REMSSEN-LAKE PLACID TRAVEL CORRIDOR PROPOSED FINAL AMENDMENT / FINAL SUPPLEMENTAL EIS

**1996 Remsen-Lake Placid Travel Corridor
Unit Management Plan /
Environmental Impact Statement**

February 2016

Review of Rails-With-Trail Design Proposal by Trail with Rail Action Committee (TRAC)

Figure 1: Schematic depicting fill on rail bed with widened footprint (not to scale)

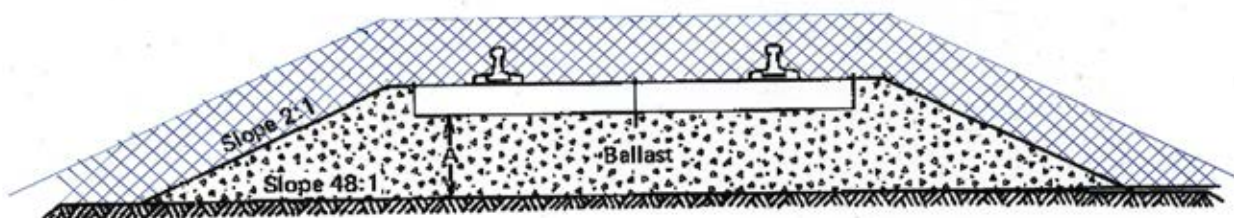
DOT estimates that if the rails were covered with trail material the trail surface would be raised by about 1 foot (See Figure 1). In raising the profile, the side slopes or embankment would also need to be widened to avoid potential problems with stability and/or settlement. This would result in significant fill outside the current footprint of the railbed and require culverts to be extended, and therefore introduce the same environmental impacts to the Corridor as described in the previous sections regarding side-by-side and on/off Corridor trails (See Appendix 3).

TRAIL SECTION: Tupper Lake, International Paper Conservation Easement

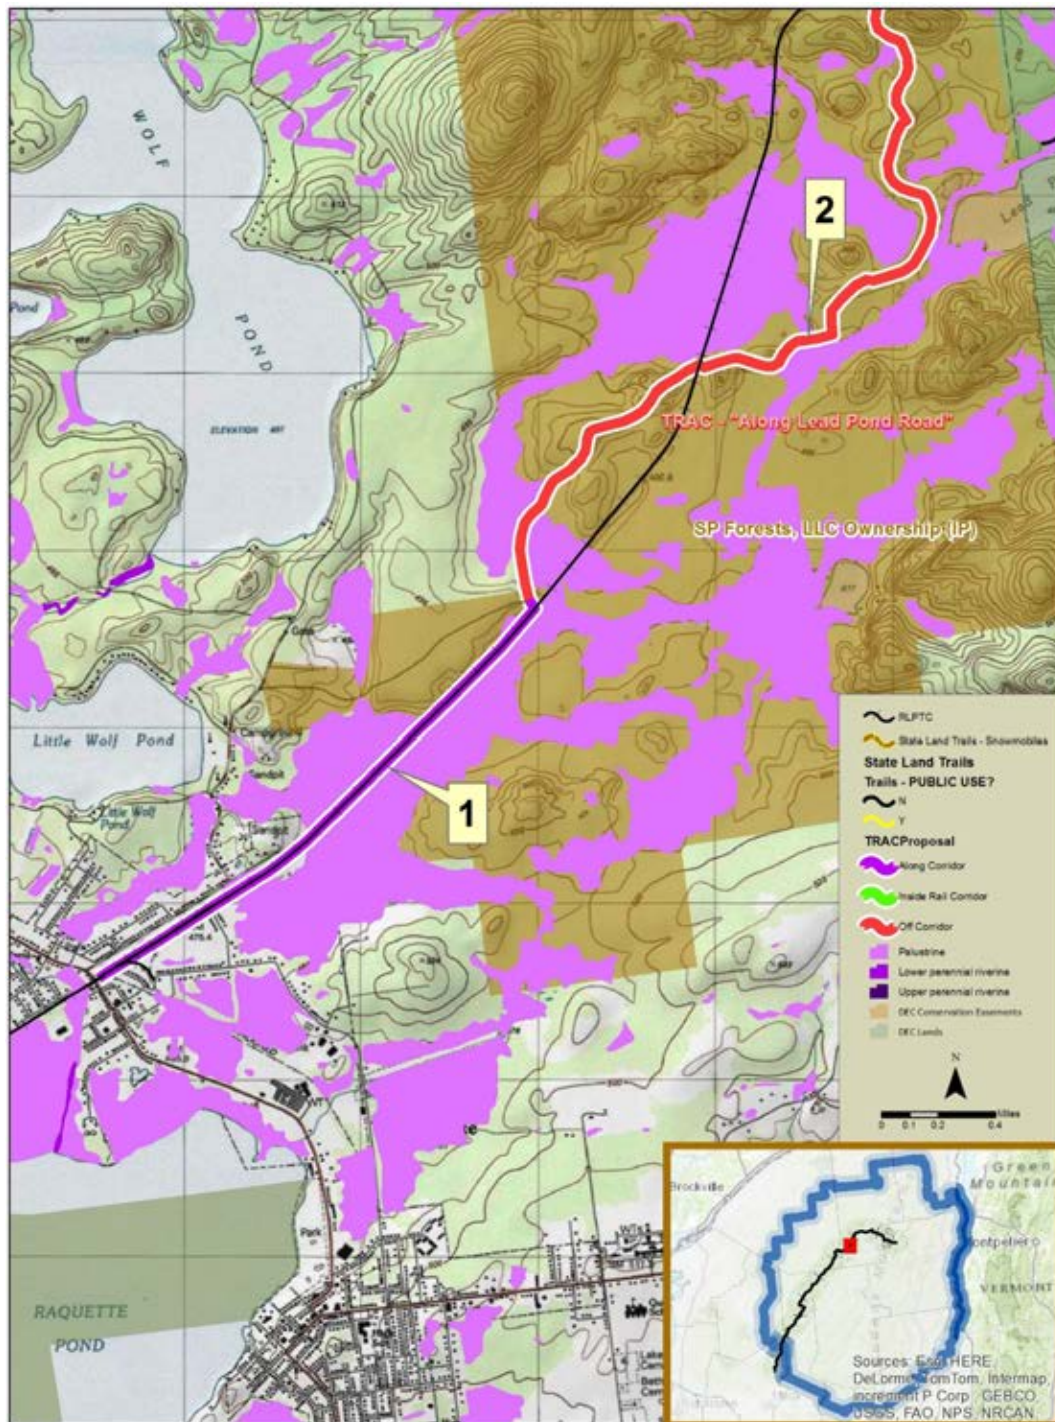
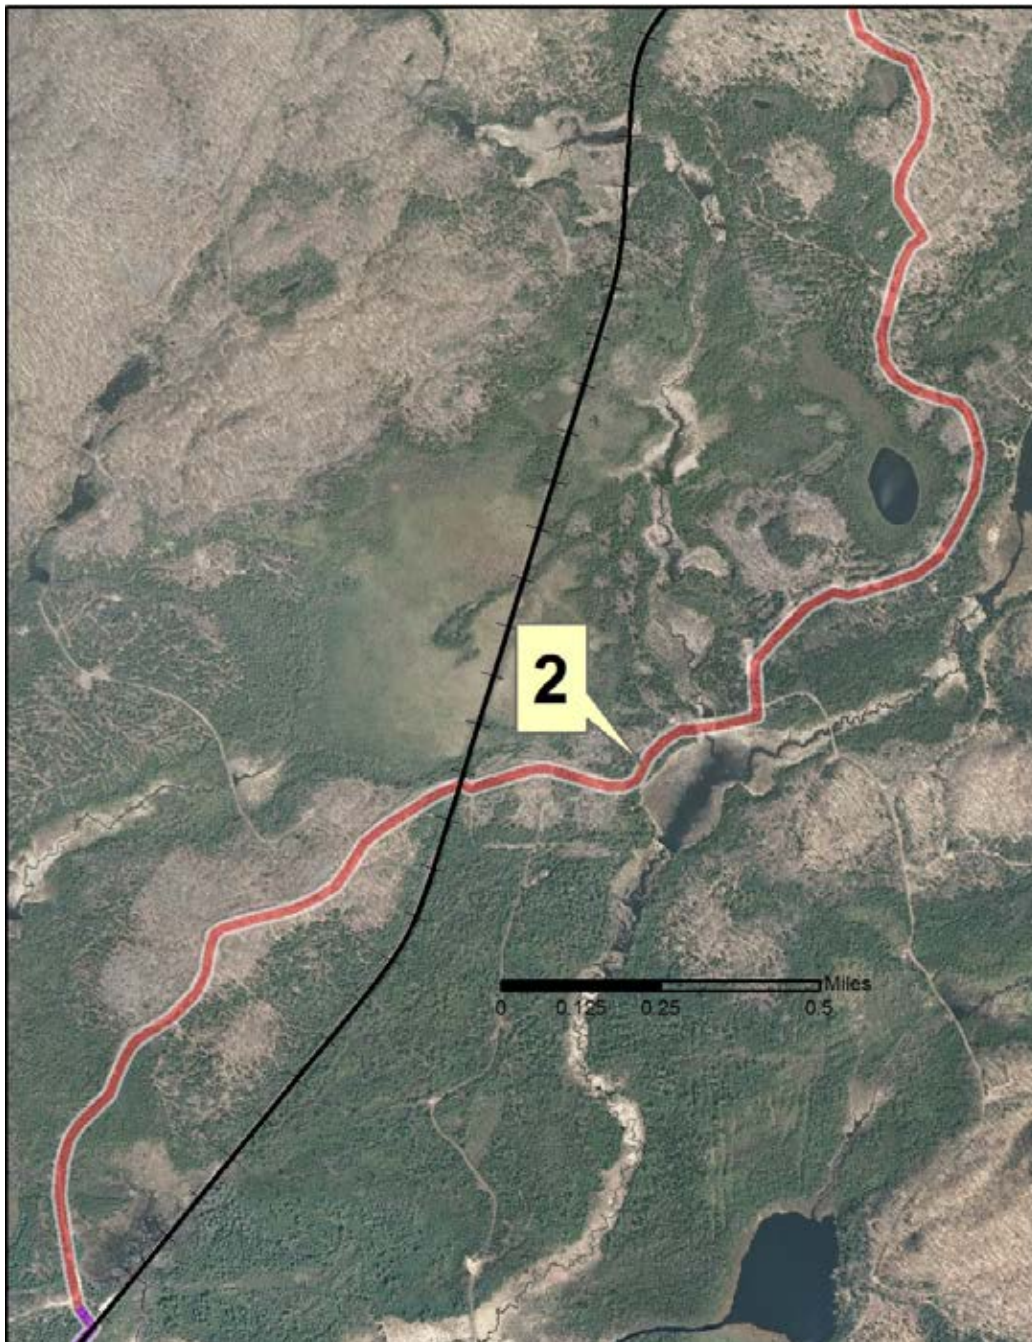
TRAC proposes to route the public “Along the Corridor” (**Map Label #1**), where an estimated 1 mile of potential wetlands would need to be filled-in to complete a parallel trail. This segment is located between Tupper Lake and the start of TRAC’s alternative route off the Corridor on the conservation easement.

TRAC's suggested route off the Corridor in this segment (**Map Label #2**), could potentially become a public trail. The route shown uses logging/skid roads and traverses some very wet areas. There is potential to re-route TRAC's route through drier areas on this easement. It is important to note that the roads/trails on this property are shared with leased hunting camps and logging operations, so safety and user experiences relating to this must be taken into consideration. Snowmobiling and biking could both be theoretically possible off the Corridor in this easement.

**TRAIL SECTION:
International Paper Conservation Easement to Rollins Pond**

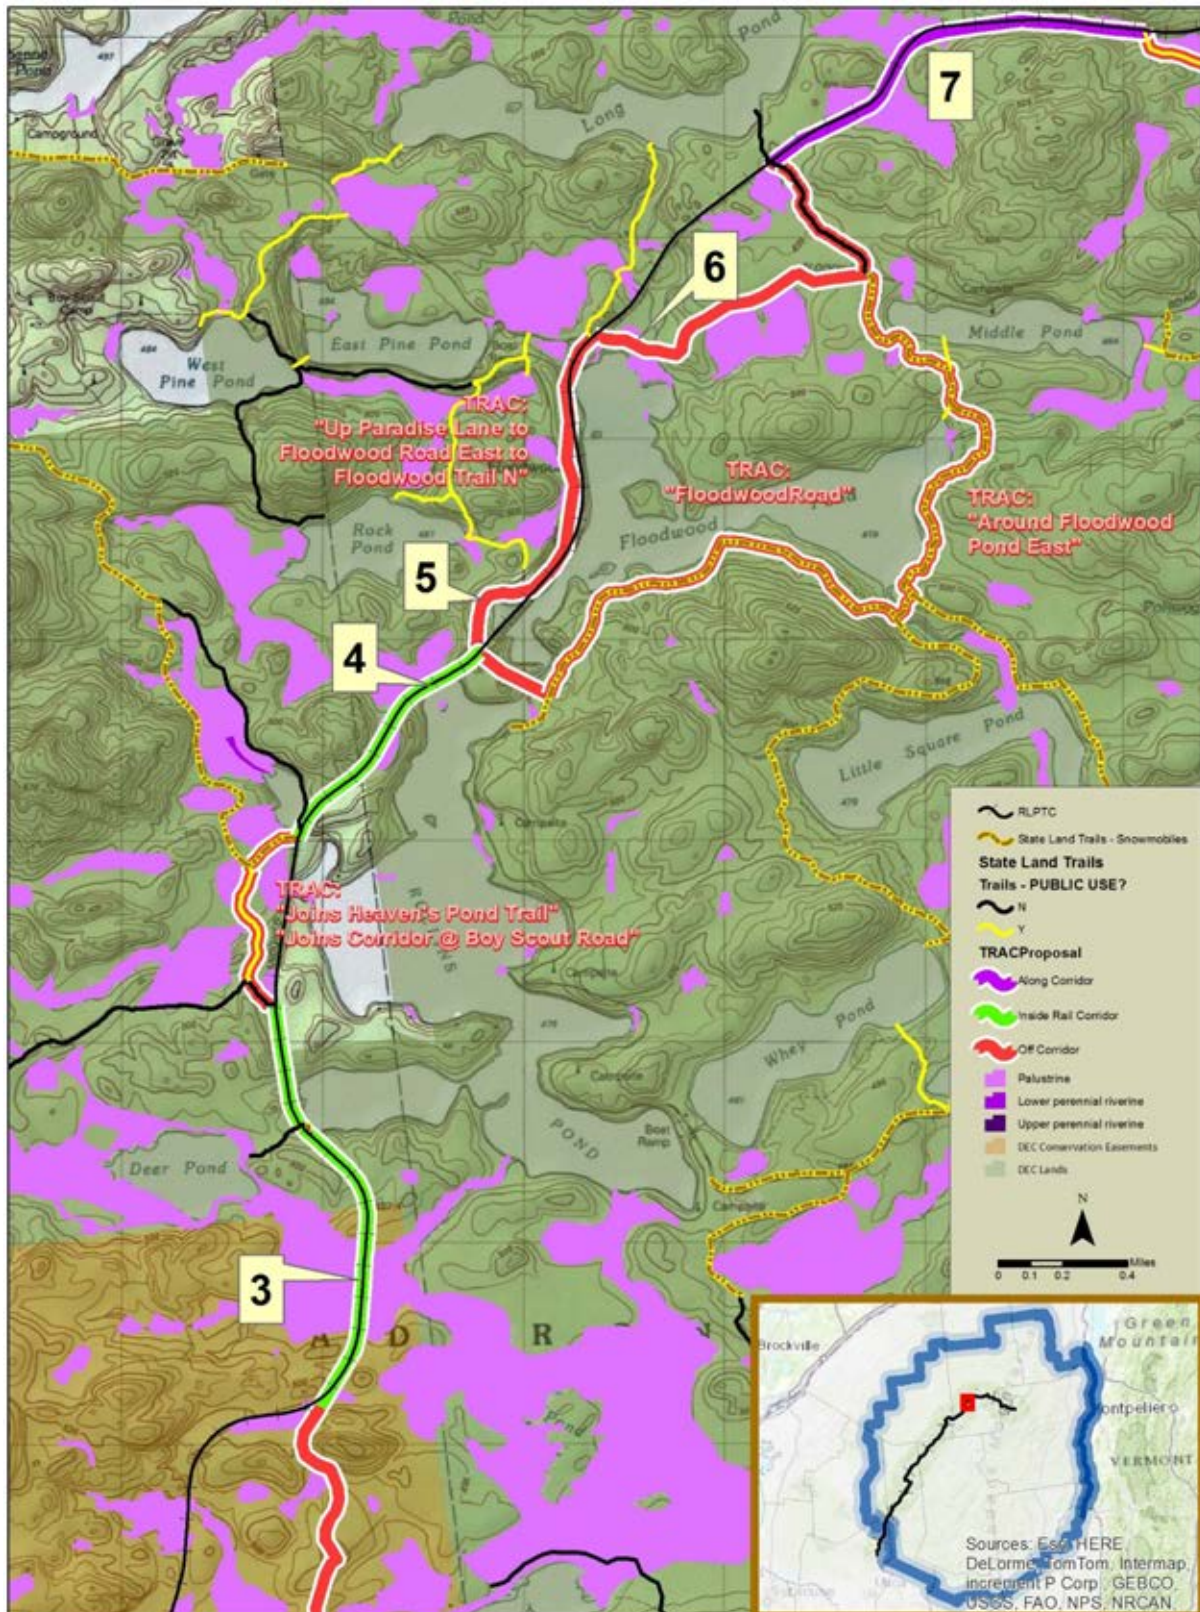
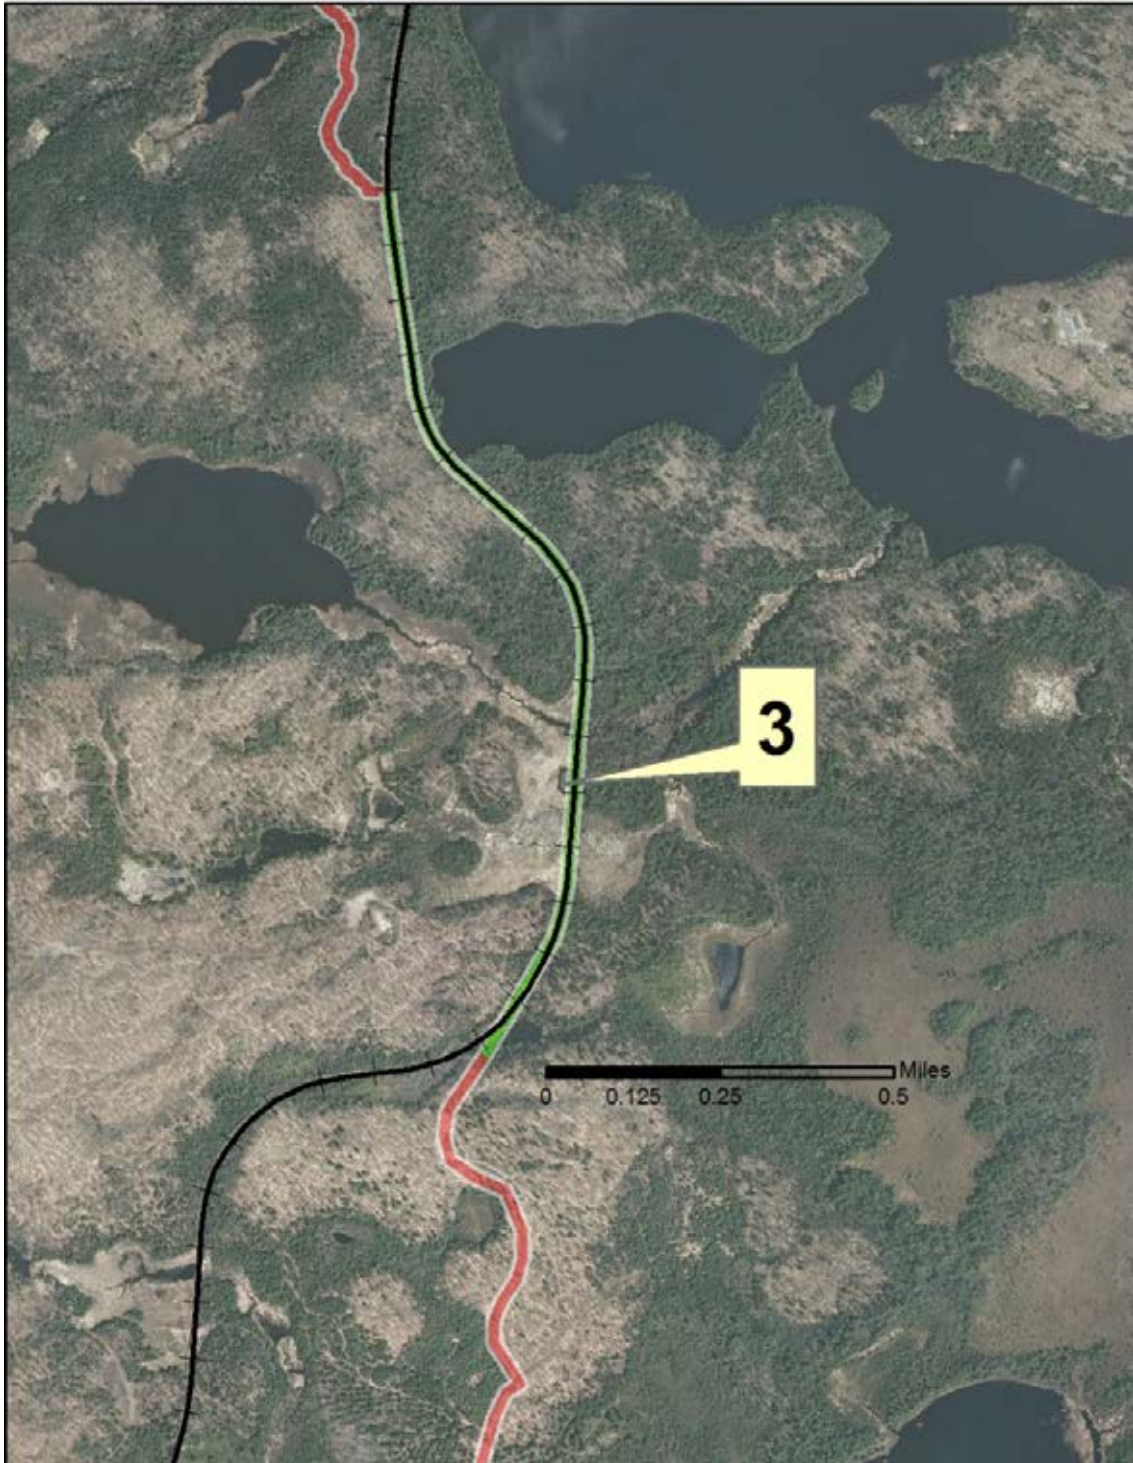
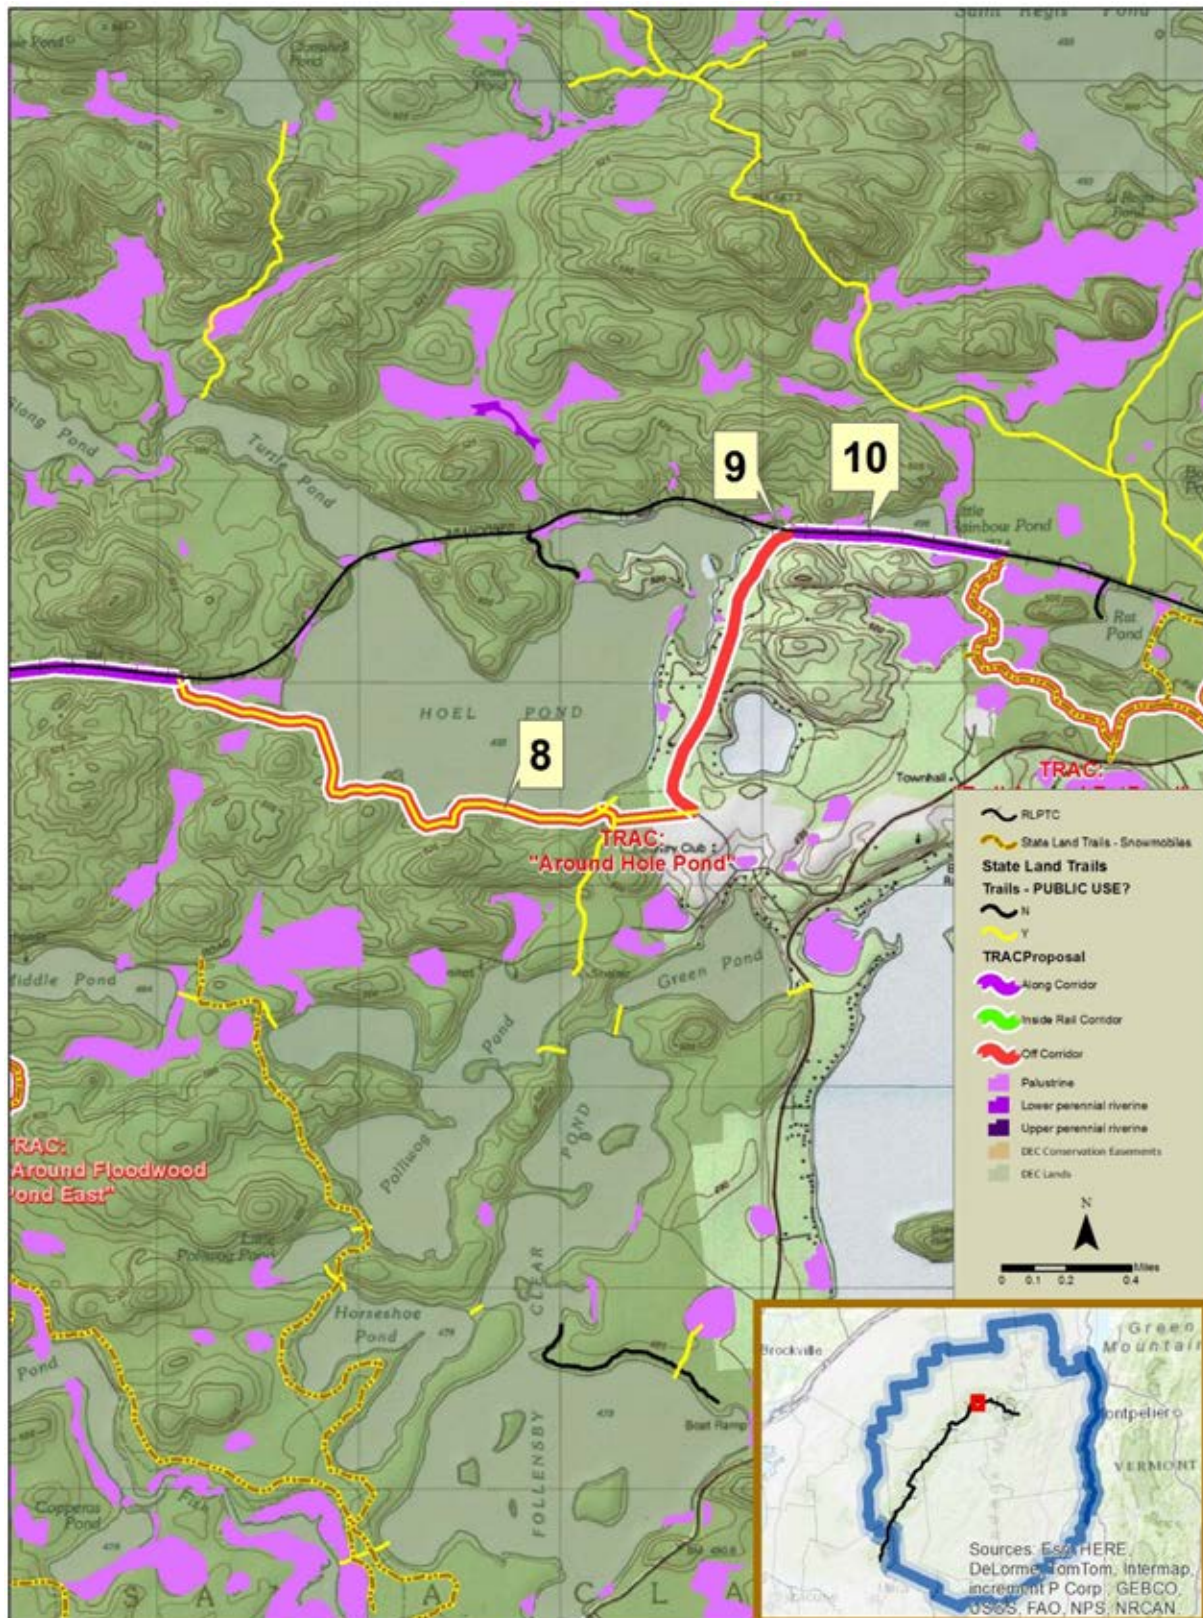
The segment of trail “Inside the Rail Corridor” TRAC proposes in the vicinity of **Map Point #3** passes through significant wetlands that would need to be filled-in, for an estimated 1/3 of a mile.

Map Point #5 shows the vicinity of Paradise Lane. This part of TRAC's alternative is probably not feasible because that road is mostly privately-owned, and therefore would require private landowner permissions.

Map Point #6 notes where a significant bridge would need to be built at the Rollins Pond outlet, in order for this alternative to be feasible. This bridge is highly desirable

from a DEC perspective for trail connections with the Rollins Pond/Fish Creek Campgrounds. That would make TRAC's Floodwood Road route possible. Some sections of TRAC's Floodwood Road loop would need to be improved and opened to public use.

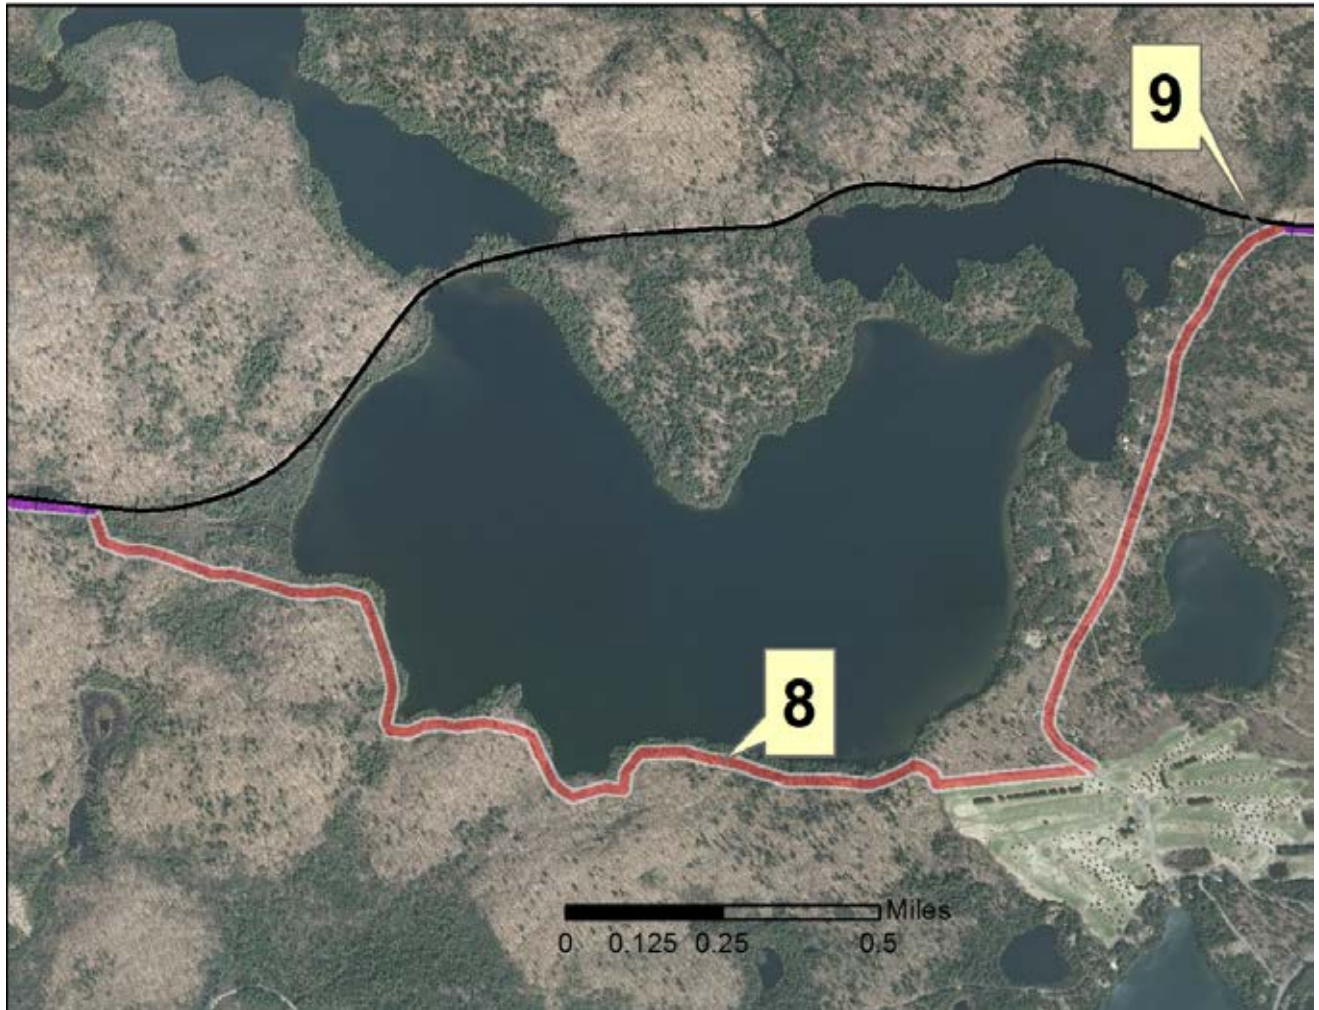
Map Point #7 shows where TRAC proposes a segment approximately 0.5 miles “Along Corridor”, which would result in adverse impact or loss of regulated wetlands.
